The Exchange (P18-0091-0101, P18-0401 & P18-0424), Exhibit 9 - Applicant Prepared Variance Justifications

Re: Comment on the The Exchange aka P18-0091 (GP), P18-0092 (RZ), P18-0093(PPE), P18-0094-0098(CUP), P18-0101(DR), P18-0424 (GE), P18-0100 (MCUP) and P18-0401(EIR)

Re: Response to Environmental Impact Report for The Exchange Project

Exhibit 8-2 included in the Urban Crossroads TIA report dated November 30, 2018 (EIR Appendix L: Traffic Impact Assessment)

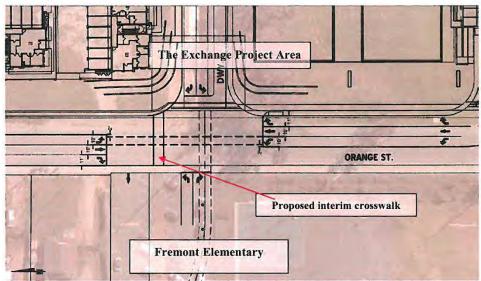
- a. The interim intersection layout has a proposed crosswalk aligning with the median of the existing Fremont parking lot. This will result in a significant safety hazard of students having to cross vehicle traffic on Orange Street and at either one of the two Fremont driveways to access the school's on-site walkways.

The interim layout, as proposed, does not comply with the Education or Mobility Elements of the City of Riverside General Plan 2025 for Safe Routes to Schools. City Policy CCM-8.2 is to promote walking and biking as a safe mode of travel for children attending local schools. CCM-8.3 is to apply traffic management

Exhibit 8-3, the "ultimate design" included in the Urban Crossroads TIA report dated November 30, 2018. Shows an alteration to Fremont's parking lot that was never approved by RUSD.

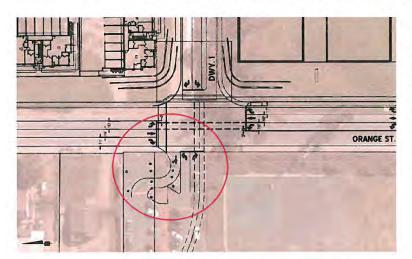
- c. Furthermore, the TIA analysis of Driveway 1 is invalid. The TIA concludes that there is no significant impact at Driveway 1, however, this conclusion is based on using the ultimate intersection layout. The ultimate intersection layout depicts an alteration of Fremont's north driveway that was never approved by RUSD.

As stated in previous communications with the City and developer, this proposed driveway alteration <u>must impose no financial responsibility to RUSD</u> for the cost of the construction. RUSD has no plans to implement such a proposed alteration. It was RUSD's understanding that the ultimate layout would <u>not</u> be proposed to be implemented as part of the project. Therefore, is should not be utilized to conclude that the project will not have an impact. Any such proposed alteration must be planned and authorized with District Planning and Development staff prior to the Planning Commission meeting on March 21, 2019.

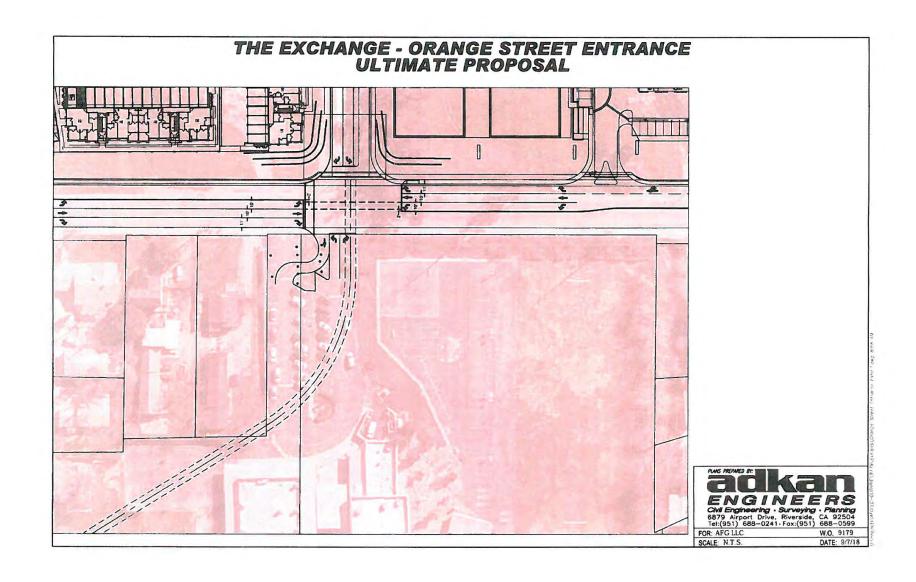
Mr. Guthrie has submitted two (2) options to the City of Riverside: Interim Option and Ultimate Option (enclosed). The Ultimate Option shows a drive approach relocation to the easterly side of the existing parking lot. These options were submitted to the City after our meeting without RUSD's review. We have informed Mr. Guthrie that RUSD did not intend, nor has it planned, changes to the existing parking lot during our project. RUSD does not have the resources to add these changes to our scope of work. Additionally, the modifications in the Ultimate design reduce the number of existing parking stalls at a school where parking is already severely impacted.

To date we have no futher information regarding the apartment complex planned by Mr. Guthrie. This letter serves to notify the City of Riverside that RUSD has not planned or approved the changes in the Ultimate Design Option. If you have any questions or concerns, please contact the undersigned at (951) 788-7496.
